CABINET MEMBER FOR ENVIRONMENT – 27 FEBRUARY 2014

AMENDMENTS TO PROPOSED RESIDENTS PARKING SCHEME CUTTESLOWE AREA, OXFORD

Report by Deputy Director for Environment & Economy (Commercial)

DRAWING TITLE
**REVISED PROPOSALS
EAST SIDE**

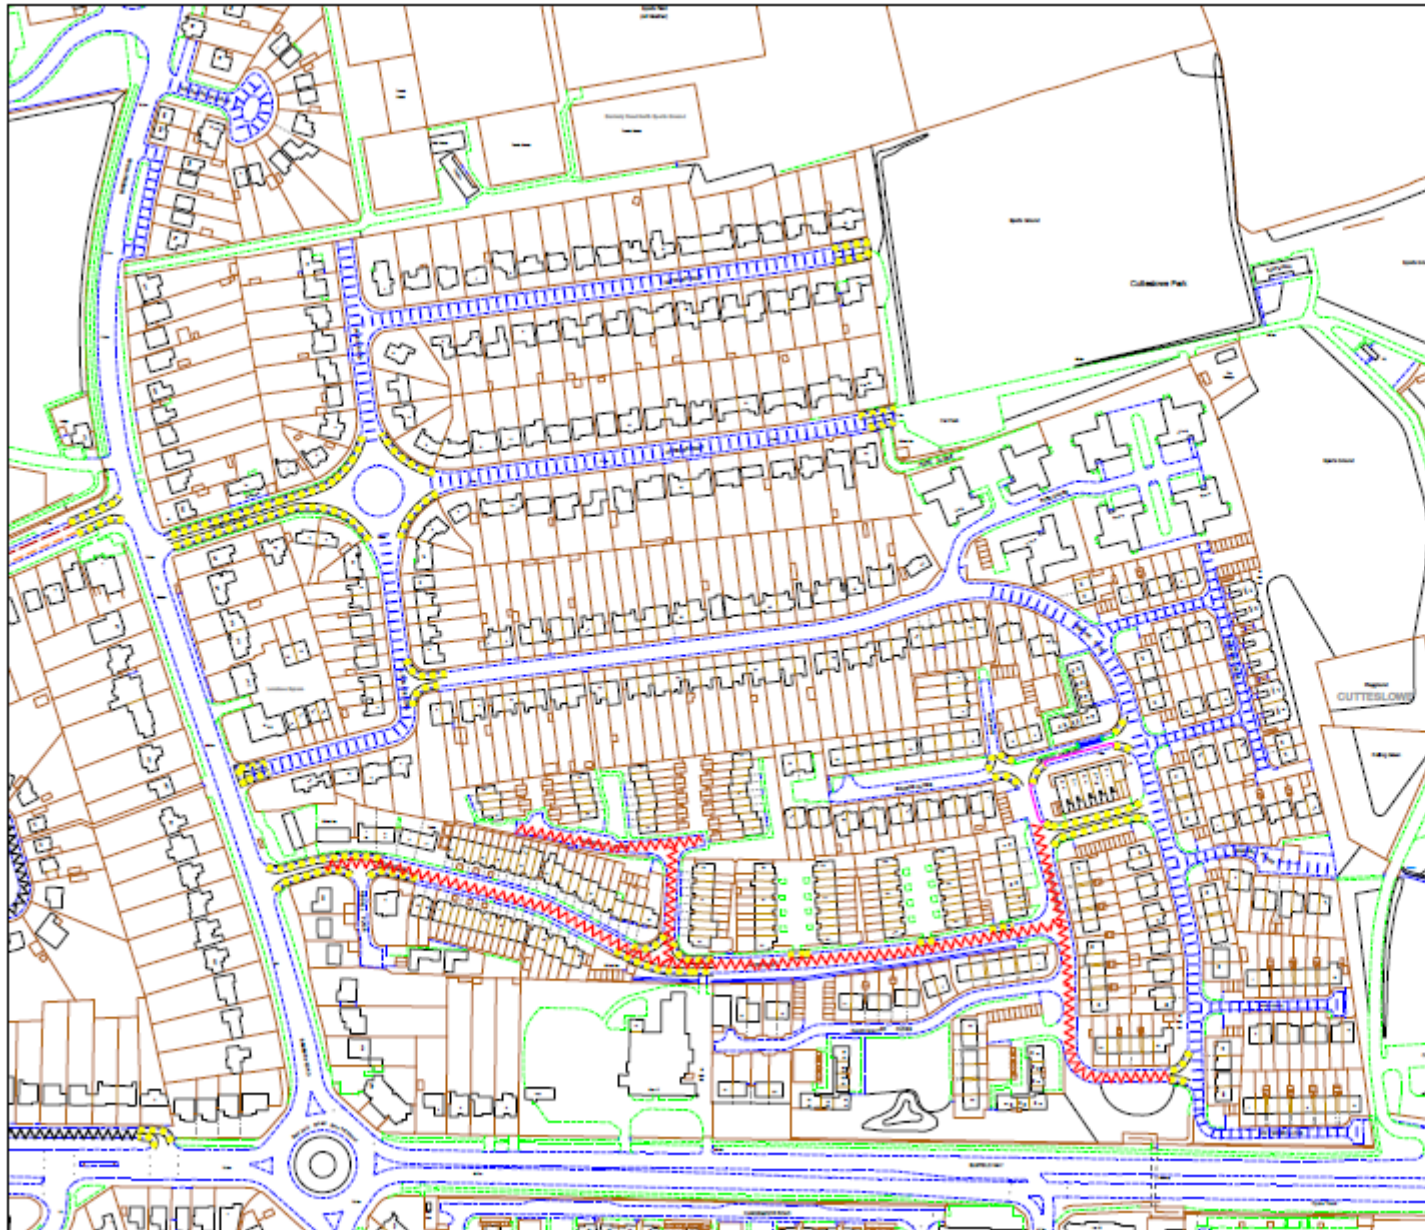
Secretary of The Harbord Road Area Residents' Association	Requests some one-hour parking / residents only parking bays on the stretch of Harbord Road between the roundabout and the Banbury Road as this would <ul style="list-style-type: none"> • help to avoid "boy-racer" issues along that bit of road (this is a problem) • would provide some short term parking areas for non-residents • would provide parking spaces for visitors to this part of Harbord Road • would provide parking for the significant number of cars which currently park on the roundabout which will be displaced by the double yellow lines 	Following comments made in response to this consultation it is now proposed that a short length of 2-hour shared use parking is introduced on the south side of this section of road, in a location that will not interfere with any driveways.
Resident, Harbord Road	Offers continued support of the scheme and hope that its implementation will be able to proceed shortly after completing the consultation process. Is particularly in favour of the proposal to extend double yellow lines up to and including the roundabout in Harbord Road. Believes that the decision to provide permit holders only parking in Hayward and Talbot Roads and the	This resident has subsequently been consulted on the proposal to introduce a short length of 2-hour shared use parking on the south side of this section of road,

<p>Resident, Harbord Road</p>	<p>Would like to see a very few (one or two) residents or one hour parking places between the Banbury Road and the mini roundabout in Harbord Road, which would also act as a traffic calming measure.</p>	<p>Following comments made in response to this consultation it is now proposed that a short length of 2-hour shared use parking is introduced on the south side of this section of road, in a location that will not interfere with any driveways.</p>
<p>Resident Harbord Road</p>	<p>Is wholly in favour of the proposals for Harbord Road subject to two reservations A) will it happen at once and not be subject to further quest for the ideal solution? B) the proposed closing time of 5p.m is not really satisfactory and fails to recognise Harbord's special problem from the charging system in the park.</p>	<p>It is not intended that there will be further consultation. The choice of 5pm represents a compromise between the competing requests of residents</p>

Resident, Templar Road	Would like to thank Councillor Fooks for listening and being prepared to adapt the scheme, since the parking issue, is NOT the same in all roads in the area and consequently some residents are more affected than others. In the case of the upper part of Templar Road we are not affected and would prefer not to have parking restrictions with the attendant permit costs, matters of enforcement and resulting change to the residential road character which this creates. Thinks it would be a very sad step indeed if we were to have parking restrictions. It would be a form of coercion for the wrong reasons. Why	The scheme approved in 2013 specifically excluded the western section of Templar Road from any restrictions. However, it is clear from the responses to this (2014) consultation that a significant number of residents in this part of Templar Road now wish for restrictions to cover the whole road. It is therefore

<p>Resident, Templar Road,</p>	<p>Lives in section of Templar Road, opposite Park Close. Has never had problem with anyone parking outside house as has a drive so it is left clear. Hopes home is not included in the proposals and will strongly fight any resident parking permits.</p>	<p>It is clear from the responses to this consultation that a significant number of residents in the western part of Templar Road now wish for restrictions to cover the whole road. It is therefore proposed that the scheme be so amended.</p>
<p>Resident, Templar Road</p>	<p>Occupant of property close to where the parking permit scheme is proposed to start. Doesn't see the benefit of introducing such parking at this location given that all parking west of our house is to remain normal there is no reason for permit parking.</p> <p>Location is some distance from public access to the park and to be charged to park outside our home on the basis that the public 'may' park in our area is something that just simply doesn't make sense.</p> <p>Strongly believes that the parking should be introduced from the grass verge</p>	<p>It is clear from the responses to this consultation that a significant number of residents in the western part of Templar Road now wish for restrictions to cover the whole road. It is therefore proposed that the scheme be so amended.</p>

Resident, Templar Road	<p>Are very very much in favour of the remaining section of Templar Road being included in the same restrictions as in the plan for the rest of the area, as proposed in the above mentioned letter.</p>	<p>It is clear from the responses to this consultation that a significant number of residents in the western part of Templar Road now wish for restrictions to cover the whole road. It is therefore proposed that the scheme be so amended.</p>
Two residents, Templar Road	<p>Live in the part of Templar Road which currently won't be getting the parking permit scheme. Would like to take the opportunity to convey that they are very against this and strongly in favour that all of Templar Road should have the same parking permit/restrictions as surrounding roads. As most of the other roads in the Cutteslowe and Five Mile Drive area will have parking restrictions it will inevitably attract many city centre and park goers to park in the unrestricted section of Templar Road and leave residents on Templar Road with very little parking options. Further, would like to point out that the No 17 bus also comes down Templar Rd and if the road is fully parked by cars it will mean that the bus won't be</p>	<p>It is clear from the responses to this consultation that a significant number of residents in the western part of Templar Road now wish for restrictions to cover the whole road. It is therefore proposed that the scheme be so amended.</p>

Resident, Templar Road	As a resident in the western end of Templar Road it is of the opinion that the restrictions proposed for the eastern end of Templar Road should be extended to encompass the whole of Templar Road, otherwise parking is likely to be displaced towards the western end.	It is clear from the responses to this consultation that a significant number of residents in the western part of Templar Road now wish for restrictions to cover the whole road. It is therefore proposed that the scheme be so amended.
Resident, Templar Road	Would like to state strong concern and opposition to these proposals. Has recently moved into the area and now lives on one of the few streets (Templar Road west of Park Close) that would not be subject to any restrictions. Based on the current proposal, it is highly likely that our street would be subject to significantly increased traffic and parking from non-residents, making it difficult for the actual residents to find parking close to home. Would be more than happy to be subject to the same restrictions as the other streets in the neighbourhood and pay for 2 parking permits.	It is clear from the responses to this consultation that a significant number of residents in the western part of Templar Road now wish for restrictions to cover the whole road. It is therefore proposed that the scheme be so amended.

Resident, Templar Road	As a resident of Templar Road would like to request that this road also has Parking permits to prevent the road being used as a free parking zone. This seems to be the only solution, since all the surrounding roads will have restrictions; otherwise all cars will use it as a free parking area.	It is clear from the responses to this consultation that a significant number of residents in the western part of Templar Road now wish for restrictions to cover the whole road. It is therefore proposed that the scheme be so amended.
Two residents, Templar Road	Live in the section of Templar Road in the zone that is to remain unrestricted and have grave concerns about this. Certain that the knock on effect of the proposed restrictions is that we will not be able to park outside the property as non-residents will rapidly use all the free spaces. If there are to be parking restrictions further up our street then feel that they should be treated in the same way as the overspill of cars would impact on our part of the street making it impossible to ensure we could park outside our house.	It is clear from the responses to this consultation that a significant number of residents in the western part of Templar Road now wish for restrictions to cover the whole road. It is therefore proposed that the scheme be so amended.

Two residents, Templar Road.	Certainly do not want Templar Road to become a commuter parking area, so under the circumstances there seems no alternative but to ask that we, too, have parking restrictions.	It is clear from the responses to this consultation that a significant number of residents in the western part of Templar Road now wish for restrictions to cover the whole road. It is therefore proposed that the scheme be so amended.
Two residents, Templar Road	Would like to express in the strongest terms our disagreement at excluding Templar Road from parking restrictions. This exclusion is not logical in the context of restrictions being introduced in the roads around us and we will simply face the probability that cars excluded from parking in these roads will seek space where there are no such restrictions. At our end of Templar Road during the day there are already a number of cars parked from outside the neighbourhood and this will only get worse.	It is clear from the responses to this consultation that a significant number of residents in the western part of Templar Road now wish for restrictions to cover the whole road. It is therefore proposed that the scheme be so
